11) Dome Studs Welded

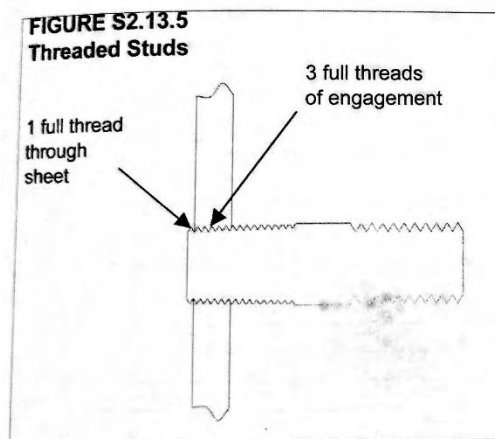
All of the dome studs have been seal welded in direct contradiction to NBIC Part 3 S2.13.5, the studs are no longer suitable for service. This in turn violates CFR49 Part 230.29 (b) (1).

- a) Studs threaded into the boiler or firebox sheets shall not be seal welded. (See NBIC Part 3, Figure S2.13.5).
- b) When studs are replaced, they shall extend at least one full thread through the sheet on the opposite side of installation. Replacement studs shall have a minimum of three threads of engagement.

13) **Rigid Bolt Telltale Holes Drilled From Both Sides**

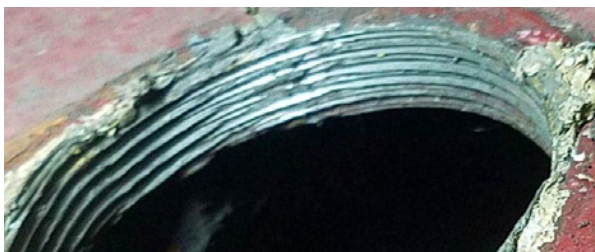
The telltale holes are drilled from both ends of the bolt, many do not lineup from one end to the other. Numerous bolts exhibit holes which are misaligned by $\frac{1}{2}$ of the hole diameter. This results in an inability to clear telltales in accordance with CFR 49 230.38 (c) as is evidenced by numerous broken drill bits left behind in the installed bolts. Bolts must be cleared so that when a bolt breaks, steam/water can be observed escaping.
